Access Compliance Report

Public Rights-of-Way

| Intersection ID: 42783 | Main Street: OLD_STONE_CROSSING_DR | Cross Street: SAWMILL_TRACE_DR | Location: NE |
| ADA ID: 0CD19912EC2B | Ramp Type: PerpDiag | Initial Pass/Fail: Fail | Overall Compliance: No |

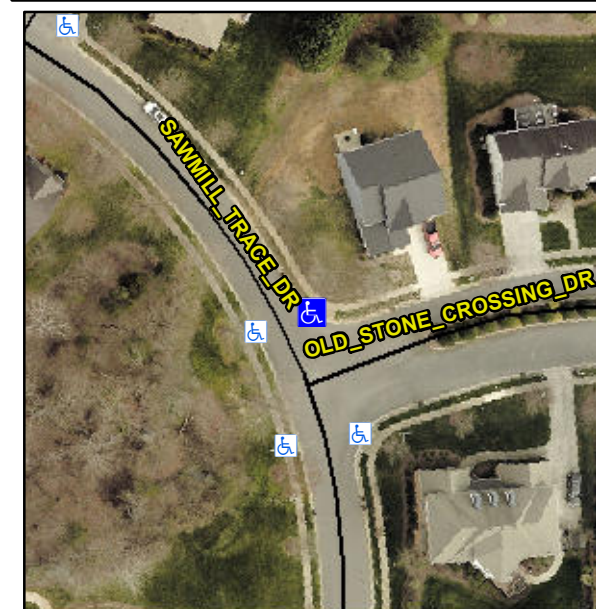
| Severity Score: 33.75 | | | |

Not Found, R304.5.1, R304.2.2

| Compliance | Description | Data | Compliance | Description | Data |
|------------|-----------------------|------|------------|-----------------------------|------|
| N/A | Ramp Length (in) | 42.5 | No | Ramp Slope (%) | 12.5 |
| No | Ramp Width (in) | 39.5 | Yes | Ramp XSlope (%) | 0.4 |

Remove & Replace Curb Ramp With Two New Directional Ramps or Equivalent.
